Reference: Proposed Aldi development – Abbey Road, Neath

Technical note

Proposed Aldi store Neath

- This technical note is provided in response to the comments received from the Environmental Health Officer at Neath Port Talbot County Borough Council, in an email from the planning officer, dated 11th February 2020, in relation to the Sharps Redmore (SR) noise assessment report (reference R1 1918927, dated 24th June 2019), that accompanied the planning application.

FIGURE 2: KKA Site Boundary Sections drawing

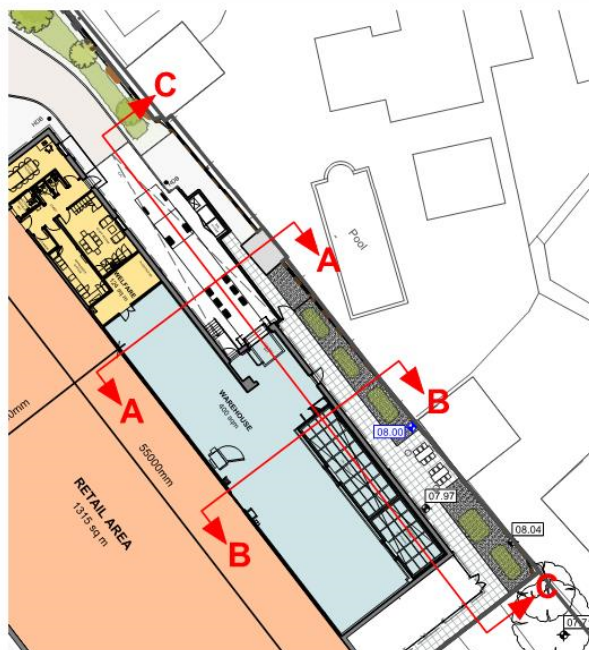
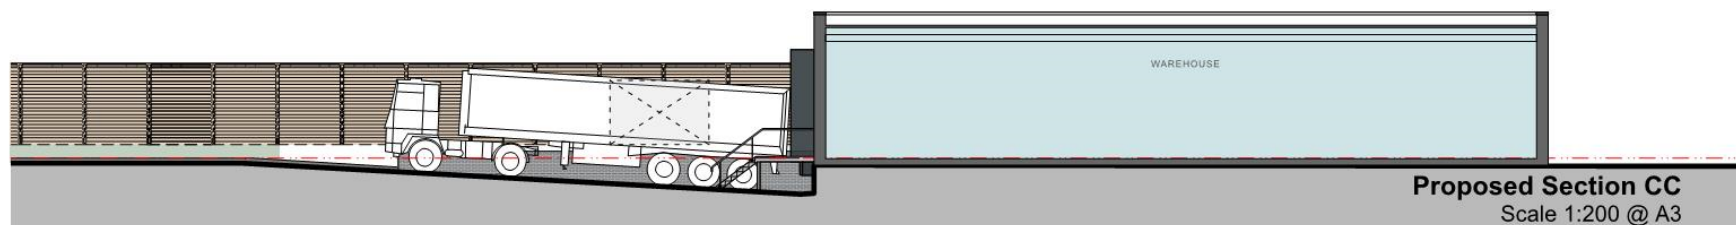
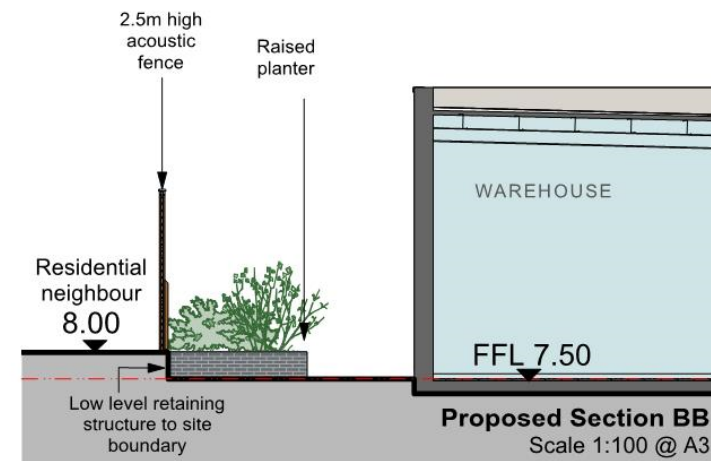
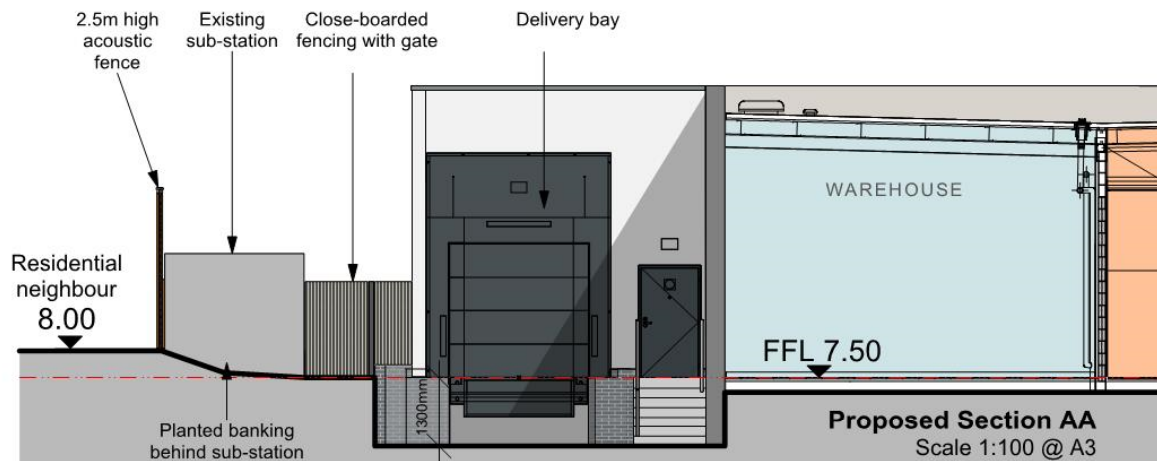
"It is noted that some barrier attenuation calculations have been included, with the source height set at 1m and the receiver height 1.5m. Would this be representative of onsite conditions? (i.e. the receiver could be on first floor of their property, the source could be a lorry which I assume would be higher than 1m)".

“More information is required on the deliveries (this should include details of the loading bay and how the delivery lorry docks)

Sections through the loading bay showing the boundaries that are proposed (it would appear there is a 2.5m boundary on the edge of the site, but the site plan also shows a bin store and what appears to be a wall, more info on this is required)”.

Kendal Kingscott Architects (KKA) Site Boundary Sections drawing 190487-1504-P1 (reproduced at Figure 2 to this note) indicates the surveyed topographical levels. Section AA shows the relative heights adjacent to the loading bay area. Due to the loading bay sloping down towards the loading dock, the source height of pallets being moved from a delivery vehicle is set down beneath the ground level of the garden at Glyn Hir. This has the effect of increasing the predicted level of screening attenuation by 2 dB, and reducing the resultant predicted delivery activity noise levels at Appendix C1 to 43 dB $L_{Aeq\ 1\ hour}$ (and 49 dB $L_{Ar\ 1\ hour}$). In turn, this has the effect of altering the outcome of the BS 4142 assessment at Appendix C3 whereby the difference between the rating level and background noise level is between -6 and -1 dB (indicative of low impact).

The KKS drawings as reproduced at Figure 2 to this technical note indicates the detail of the dock loading bay

FIGURE 3: Aldi noise barrier details

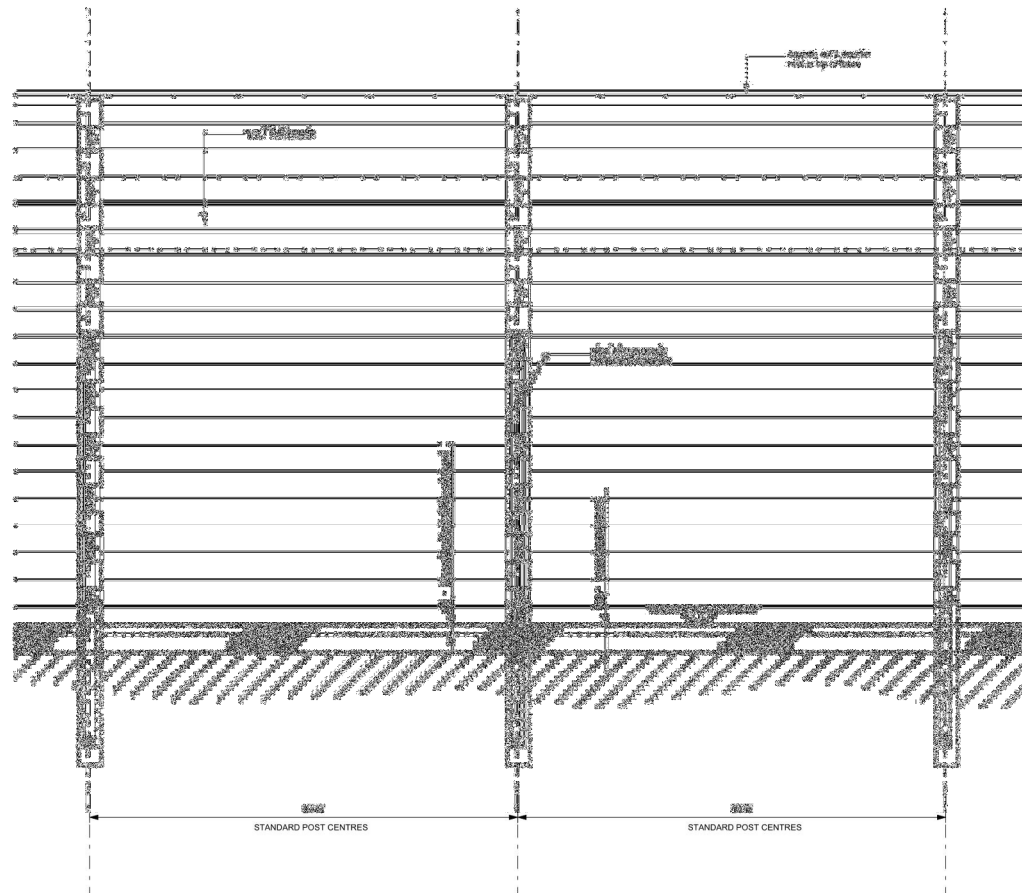
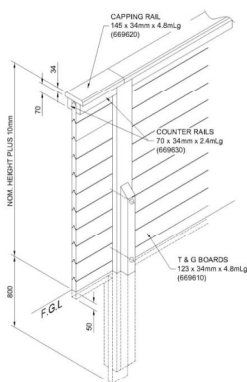
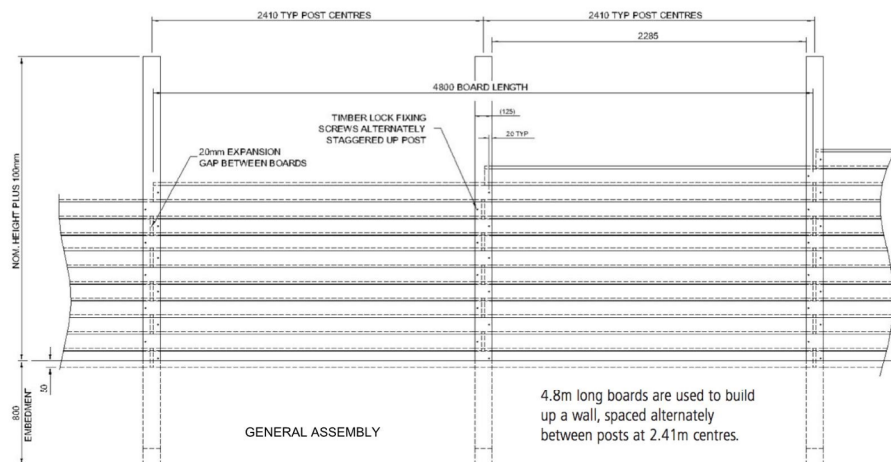
“Specification of the acoustic barriers proposed”.

Aldi noise barrier details are shown at Figure 3 to this technical note. The noise barrier should be solid, with no gaps between panels or where the barrier meets the ground, and should have a minimum density of 10 kg/m².

Note: This drawing is an illustration of the construction of a noise barrier. The proposed noise barrier at Aldi Neath would be 2.5 metres high (not the 3 metre barrier shown here).
